COMPANY: Edwin McAuley Electronics Ltd.		MODEL: TX9000LCRF	
DESC: Transmitter Board (315MHz)		VER. 1.1	
DOCUMENT NO.: TX9KLCRF_RFT01_v11			
FILENAME: TX9KLCRF_RFT01_v11.sch		SHEET: 1 OF 1

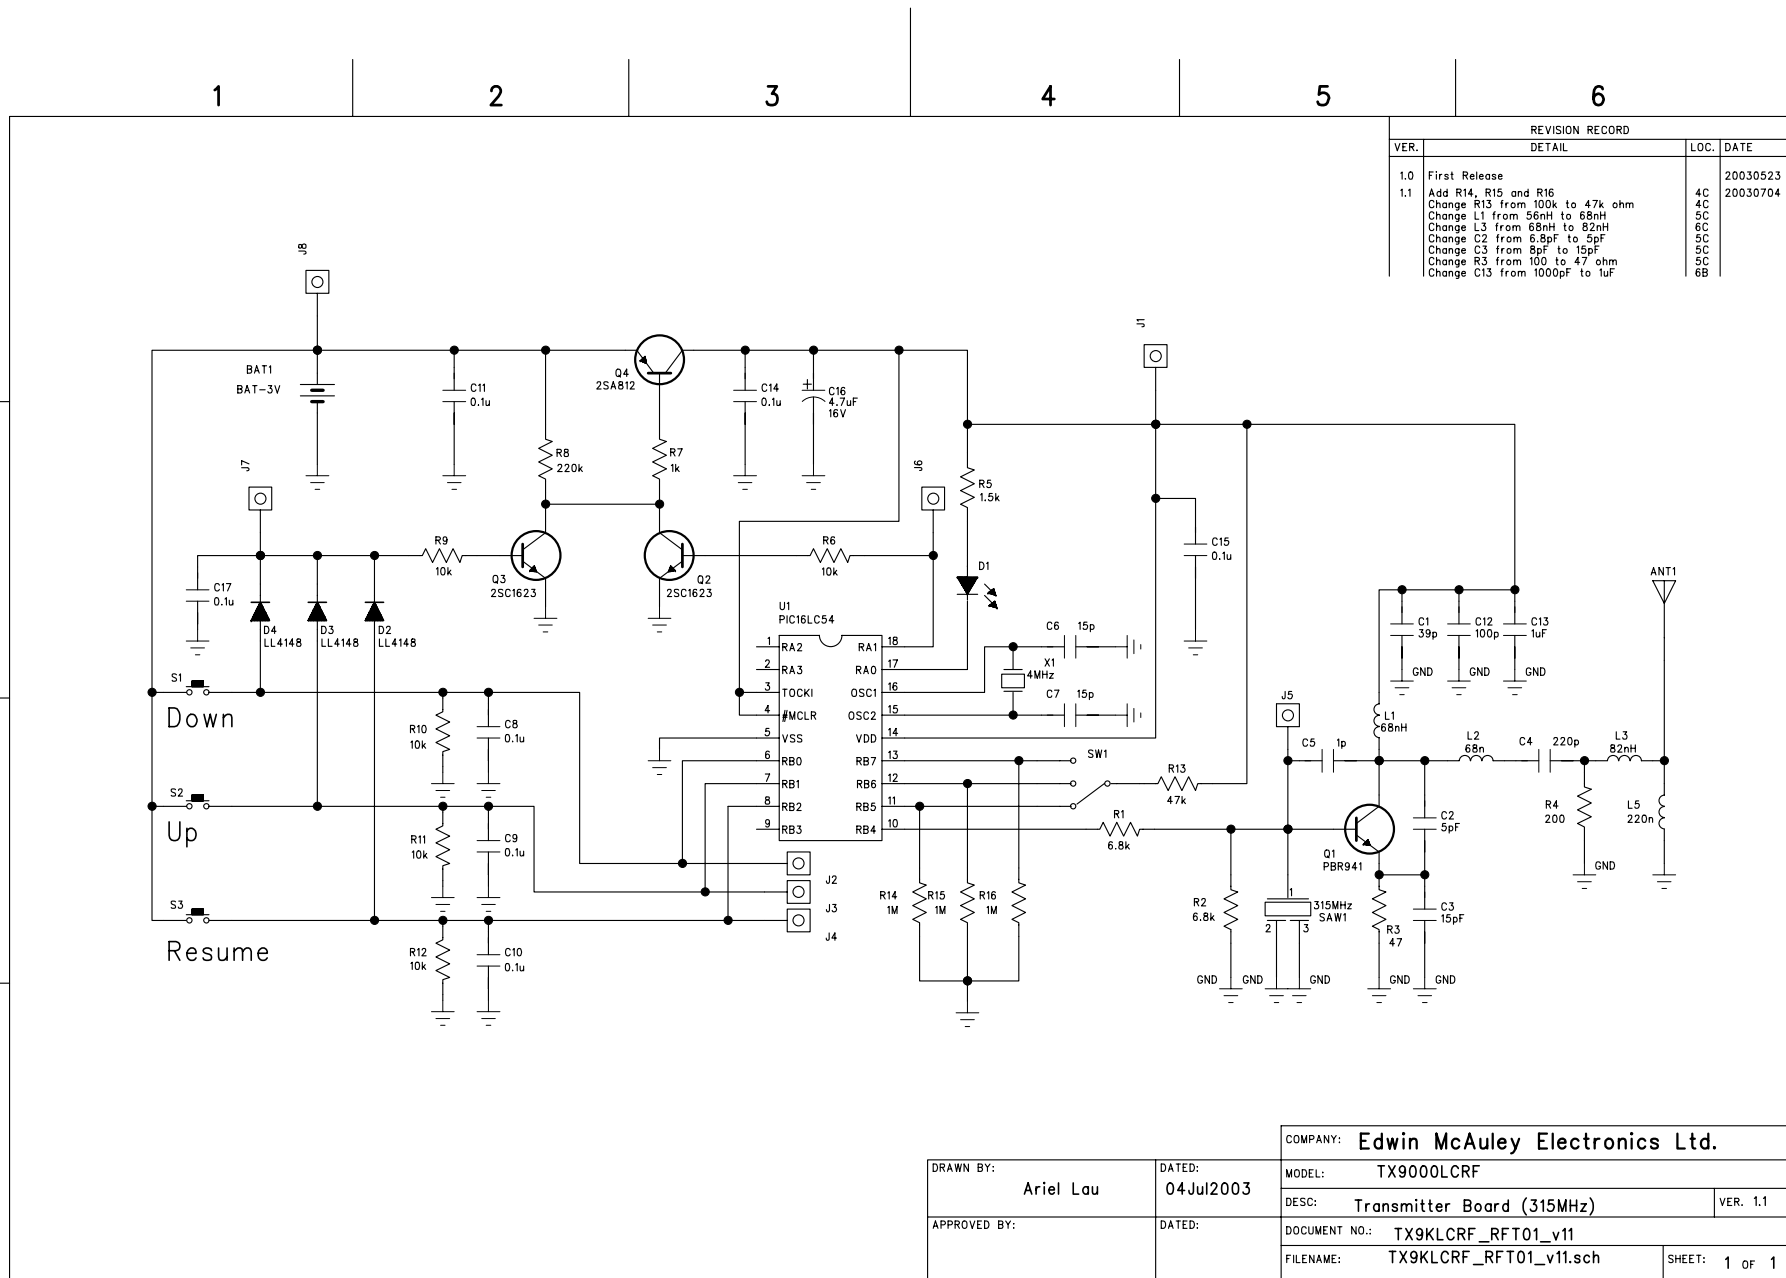
REVISION RECORD			
VER.	DETAIL	LOC.	DATE
1.0	First Release		20030523
1.1	Add R14, R15 and R16	4C	20030704
	Change R13 from 100k to 47k ohm	4C	
	Change L1 from 56nH to 68nH	5C	
	Change L3 from 68nH to 82nH	6C	
	Change C2 from 6.8pF to 5pF	5C	
	Change C3 from 8pF to 15pF	5C	
	Change R3 from 100 to 47 ohm	5C	
	Change C13 from 1000pF to 1uF	6B
